**PETITION No.:** V-137

# V-137

# Application for Variance Cobb County

Application No. V-137  
Hearing Date: 10-1-15

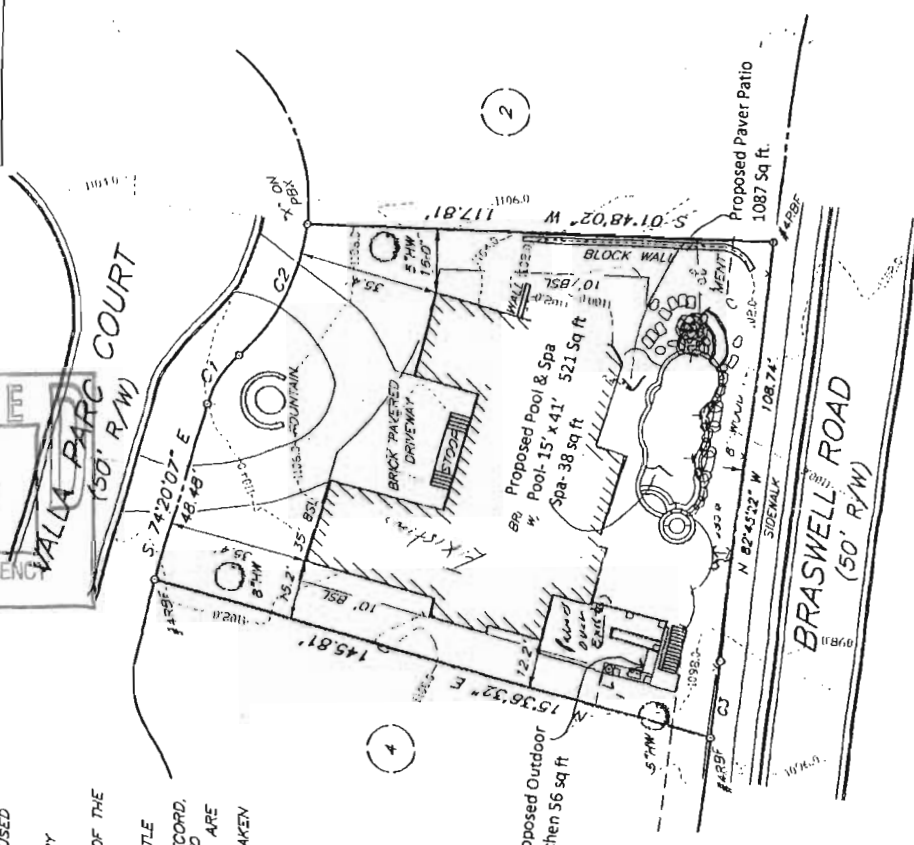
**STORMWATER MANAGEMENT:** Several of the existing improvements were not shown on the original permitted site plan. The homeowner/builder must supply verification/documentation of any infiltrator or drywell installation in order to receive any credit for runoff mitigation. If an infiltrator system was installed, any credit will likely be required to meet the existing impervious coverage. The Stormwater Management Division cannot support an “effective” impervious coverage in excess of 40%.
